PO Change Order Request Form

Change Order

Project: **McKinley Modular Classroom Building**
McKinley Elementary School
2150 East 14th Street
San Leandro CA 94577

CO #: 5
Date: 10/21/20
Contract Date: December 11, 2019
DSA Application #: 01-118102
DSA File #: 01-35

DRAWING NUMBER: **C4.0**

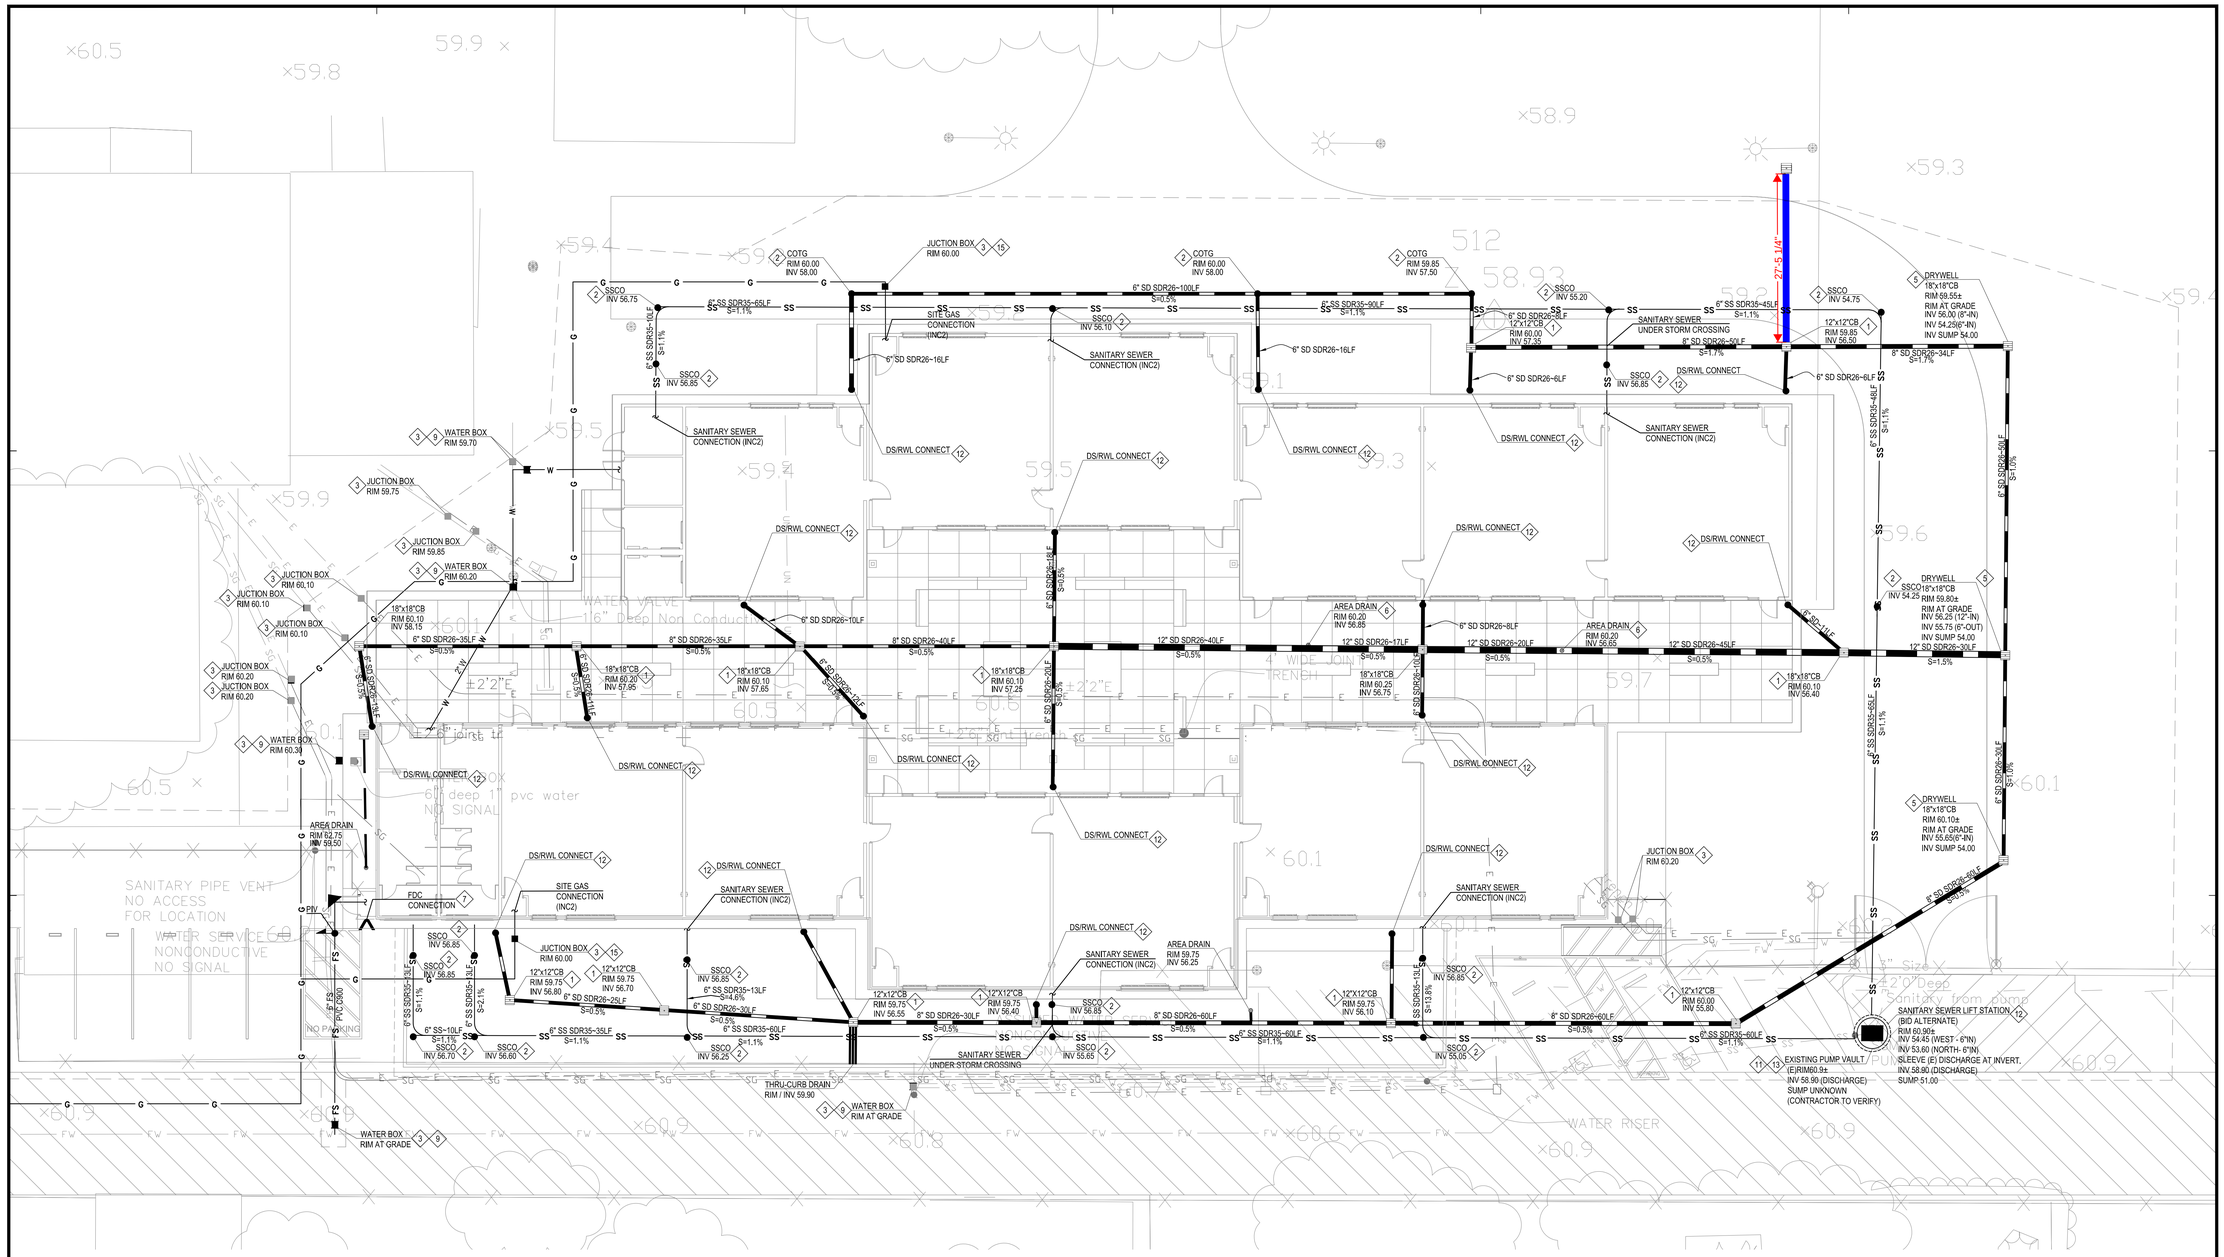
Description: Added Storm Drain Inlet

Provide and install additional storm drain inlet.

Attention: ELEANOR ALVARADO
Project: 4042 / MCKINLEY ES
Reference: ADDED STORM DRAIN INLET AND PIPE
